NOTICE OF DETERMINATION OF DEVELOPMENT APPLICATION BY THE SYDNEY NORTH PLANNING

DA0610/17

Demolition of existing structures and construction of a mixed use development comprised of shop top housing containing 56 apartments, use of ground floor commercial space as an Aldi supermarket and small retail suite, basement parking, signage and associated works

810-818 Pacific Highway GORDON NSW 2072

DRAWING TITLE
LANDSCAPE PLAN

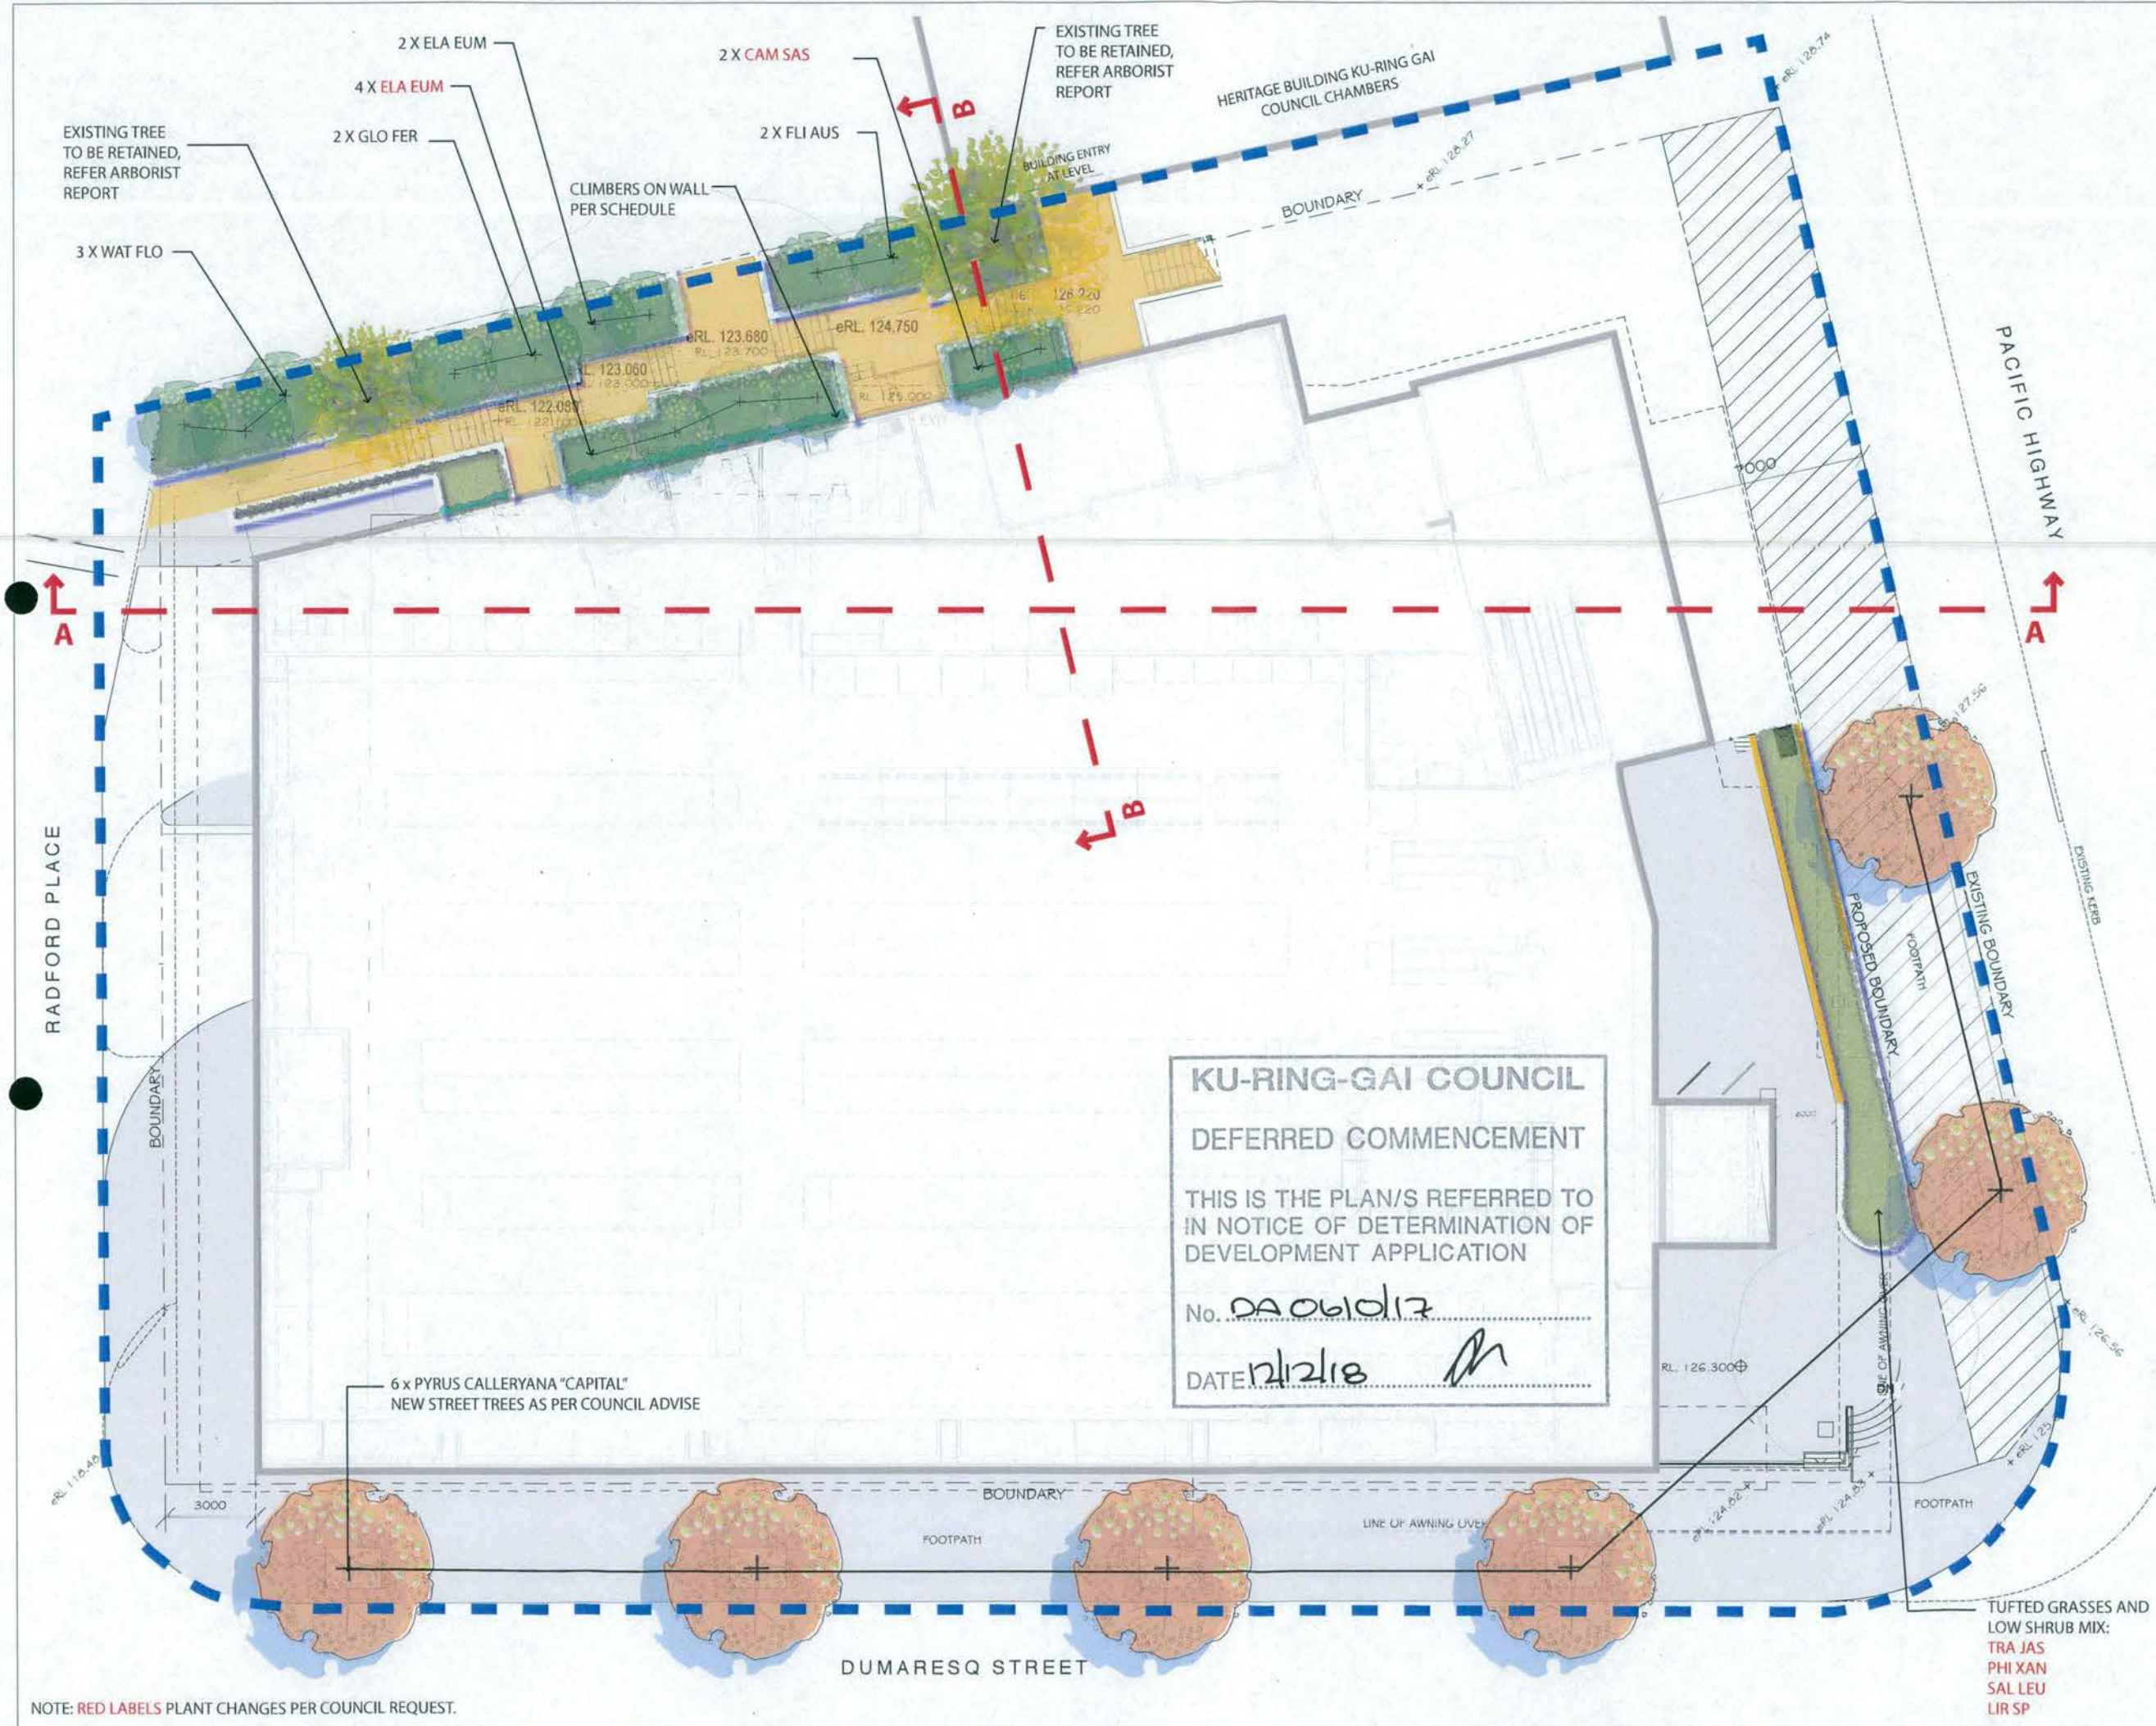
- A plan detailing the schedule of finishes is to be provided in accordance with Part 2D 1, 2 & 3 of Town Centres Public Domain Plan 2010.
- The existing paving along the Pacific Highway, Dumaesq Street and Radford Place nature strips is to be removed and replaced with the specified pavers.
- All public infrastructure is to be installed in accordance with the Technical Manual – Part 3
- To increase the soft landscaped area available for planting the paths within the ground level, private communal open spaces (COS) are to be reduced to a maximum of 1.2 metres excluding a small area immediately in front of the main entrance to the residential apartments.
- All existing trees are to be indicated on the Existing Tree Plan LA-04 in accordance with the arborist report by Joanne Leigh dated 10/10/17.

- The plans shall refer to the tree transplanting methodology outlined in the report by Tree Transplanters Australia dated November 2017.
- There is insufficient space available for the planting of 2 street trees along the Pacific Highway. To provide continuity of the street tree planting the existing *Lagerstroemia indica* (Crepe Myrtle) located on the Pacific Hwy nearest the corner of Dumaresq St is to be replaced with a *Pyrus calleryana* 'Capital'.

- An additional *Pyrus calleryana* 'Capital' is to be planted on the Radford Place nature strip midway between the corner of Dumaresq St and the carpark entrance.

- 3 x *Lagerstroemia indica* (Crepe Myrtle) are to be planted in the garden bed within the ALDI forecourt area adjacent to the Pacific Hwy.
- To ensure the long term survival of the tree and screen planting the depth of soil on podium shall be in accordance with Part 23.5 of the Local Centres DCP.

- 2 x super advanced tree specimens with a minimum container size of 200 litres are to be planted within the main COS area. The additional tree planting is to include 1 x *Nyssa sylvatica* (Tupelo) and 1 x *Jacaranda mimosifolia* (Jacaranda)

- The plans shall clearly indicate the numbers of small shrubs, ground covers and climbers to be planted
- An additional retaining wall will be required to resolve the proposed 1 metre level difference within the main COS area.

- The stormwater details are to be indicated on the plans
- The amended plans shall indicate the correct revision number and a north point.
